SUBJECT: FINAL ENVIRONMENTAL ASSESSMENT AND FINDING OF NO SIGNIFICANT IMPACT FOR UNIVERSITY OF HAWAII RELOCATION TO PIERS 34 AND 35 PROJECT, HONOLULU HARBOR, OAHU

Project Name: University of Hawaii Marine Center Relocation to Piers 34 and 35, Honolulu Harbor

Appendix D. DEA Coment Letters and Response to Comments

Figure 2-7. Location of Past Silos and Disturbance of Area to be Paved (Past and Current)

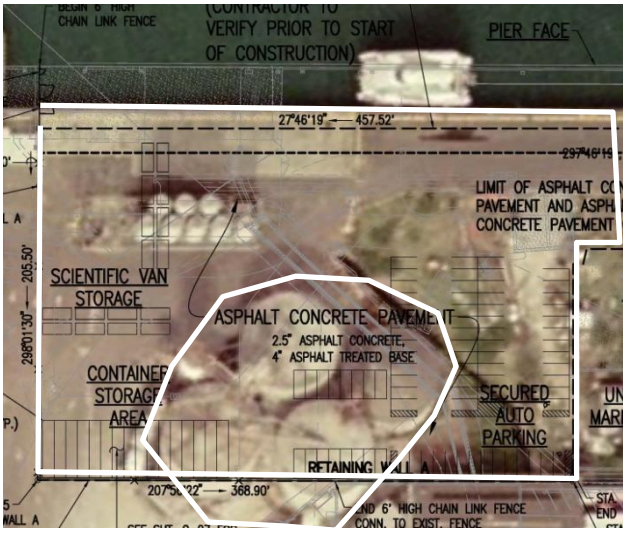
6. Figure 2-7 includes a description regarding "silos" and that "Pier 34 was used as a tank farm." Please verify the historical use of Pier 34 as a tank farm (contrary to areas annotated in photos in the draft EA) and the products or compounds that may have been used and/or stored in that area, including those easements that may cross through the area that contained petroleum pipelines, transformers, chemical storage, etc. Suggest you consult with DOT-Harbors to identify additional documents prepared for the project location that may have discussed various environmental conditions over time (for example, Earth Tech, Inc. and Oceanic Companies, 1997, *Honolulu Harbors, Iwilei Unit, Phase I Environmental Assessment, Volume I –Report and Appendices, Prepared for State of Hawaii, Department of Transportation, Harbors Division*, October; etc.)
